**From:** David\_Stewart@oxy.com  
**Sent:** Wednesday, July 13, 2016 12:16 PM  
**To:** Goetze, Phillip, EMNRD  
**Cc:** Jones, William V, EMNRD; Inge, Richard, EMNRD  
**Subject:** OXY USA Inc. - Cedar Canyon 15 SWD #1 - SWD-1510 - API No. 30-015-42797  
**Attachments:** SWD1510-CedarCanyon15SWD1.pdf; CedarCanyon15SWD1-SNTbgChg-Denied.pdf

<b>SUNDRY NOTICES AND REPORTS ON WELLS</b> (DO NOT USE THIS FORM FOR PROPOSALS TO DRILL OR TO DEEPEN OR PLUG BACK TO A DIFFERENT RESERVOIR. USE "APPLICATION FOR PERMIT" (FORM C-101) FOR SUCH PROPOSALS.)		WELL API NO. 30-015-42797

Attachment C-103  
 OXY USA Inc  
 Cedar Canyon 15 SWD #1  
 API No. 30-015-42797

Administrative Order SWD-1510  
December 11, 2014

5-1/2" & 4-1/2" Duo-Line tbg & AS pkr @ 14781'

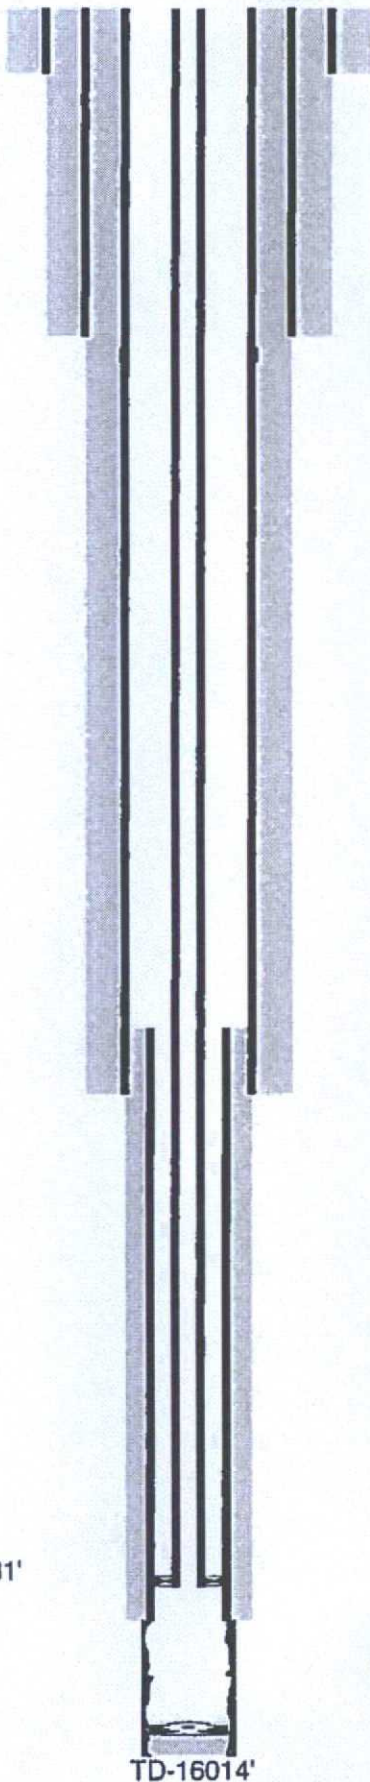
**DENIED**

TUBING SIZE SPECIFIED IN SWD ORDER. YOU MUST

SUBMIT A CHANGE TO THE SWD ORDER TO  
ALLOW FOR INCREASED TUBING SIZE.

CONTACT ENGINEERING BUREAU  
IN SANTA FE.

OXY respectfully requests to change the injection tubing string as follows:

- a. Stop injection operations
- b. Pull existing 4-1/2" 11.6# L-80 tubing out of the hole
- c. Run new tubing string of 5-1/2" 20# L-80 BTC to 9655' (100' above top of 7" liner) X/O to 4-1/2" 15.1# L-80 BTC to 14,781'. Both tubing strings will be lined internally with Duoline anti-corrosion lining
- d. OXY will notify NMOCD 24hrs prior to running MIT

I am recommending that the increase in tubing to utilize the 5 ½-inch tubing be approved with two conditions:

1. The 5 ½ inch tubing can only be used in 9 5/8-inch casing and that the reduction to the 4 ½-inch occur within the 9 5/8-inch casing prior to the top of the 7-inch liner and
2. Any SRT and resulting IPI order will be specific to the tubing set in place in the well at the time of test and for the period that that the same configuration is used for injection.

You can also state that Santa Fe will amend the order to show the tubing size change and the restrictions for use the tubing set. Since there is no current IPI for the well, there is no need to void an existing pressure increase. Is this OK with you? Thanks. PRG
